Access Compliance Report

Public Rights-of-Way

(Curb Ramps)

Intersection ID: 2964	Main Street: COTTAGE_OAKS_DR	Cross Street: WAVERLY_LYNN_LN	Location: NW
ADA ID: 5E8013B63FF4	Ramp Type: BlendTrans1	Initial Pass/Fail: Fail	Overall Compliance: No
Severity Score: 8.75			
Codes/Mitigation Info/Possible Solution		Field Measurements/Component Compliance

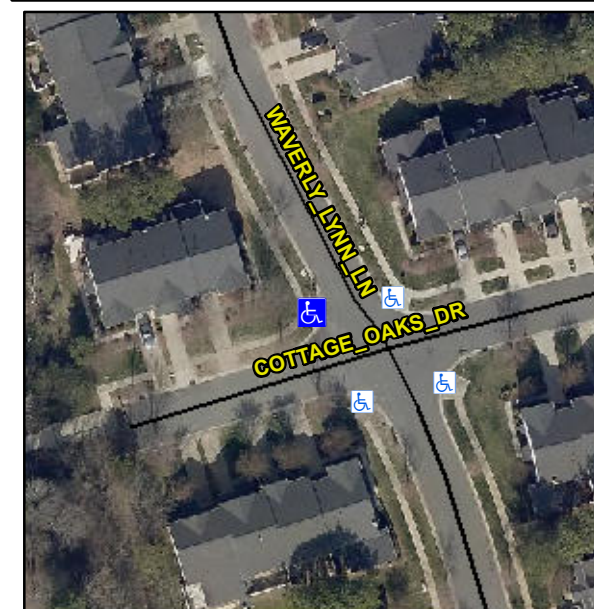
Not Found, R304.5.1

Compliance	Description	Data	Compliance	Description	Data
N/A	Ramp Length (in)	88.0	Yes	BlendTrans Slope (%)	4.5
No	Ramp Width (in)	38.0	Yes	BlendTrans XSlope (%)	1.4
N/A	Flare Type LT	N/A	N/A	Flare Type RT	N/A
N/A	Flare Slope LT (%)	N/A	N/A	Flare Slope RT (%)	N/A
N/A	Flare Traversable LT?	N/A	N/A	Flare Traversable RT?	N/A
N/A	Landing Length (in)	N/A	N/A	DWS Provided?	N/A
N/A	Landing Width (in)	N/A	N/A	DWS Contrast?	N/A
N/A	Landing Slope (%)	N/A	N/A	DWS Length (in)	N/A
N/A	Landing X Slope (%)	N/A	N/A	DWS Full Width?	N/A
N/A	Landing Curb? (Y/N)	N/A	N/A	DWS Offset (in)	N/A
N/A	Shared Landing?	N/A			
N/A	Gutter Ponding?	N/A	N/A	Gutter Slope (%)	N/A
N/A	Gutter Lip Ht (in)	N/A	N/A	Gutter X Slope (%)	N/A
N/A	Painted X Walk1?	No	N/A	Painted X Walk2?	No
	X Walk 1 Direction	To SE		X Walk 2 Direction	To E
	X Walk 1 Width (in)	N/A		X Walk 2 Width (in)	N/A
	X Walk 1 Slope (%)	4.8		X Walk 2 Slope (%)	2.8
	X Walk 1 X Slope (%)	2.2		X Walk 2 X Slope (%)	0.7

N/A	Ramp inside XWalk1?	N/A	N/A	Ramp inside XWalk2?	N/A
	Road Slope (%)	0.0		Clear Space?	N/A
	Road X Slope (%)	2.0	N/A	Clear Space to XWalk (in)	N/A
N/A	Any Obstructions?	N/A	N/A	Storm Grate/Utility Hazard?	N/A
	Obstruction Type			Storm Grate/Utility Type	
		N/A			N/A
			Yes	Surface Condition? (G/P)	Good
			No	Curb Slope (%)	14.8

Remove & Replace Curb Ramp With Two New Directional Ramps or Equivalent.
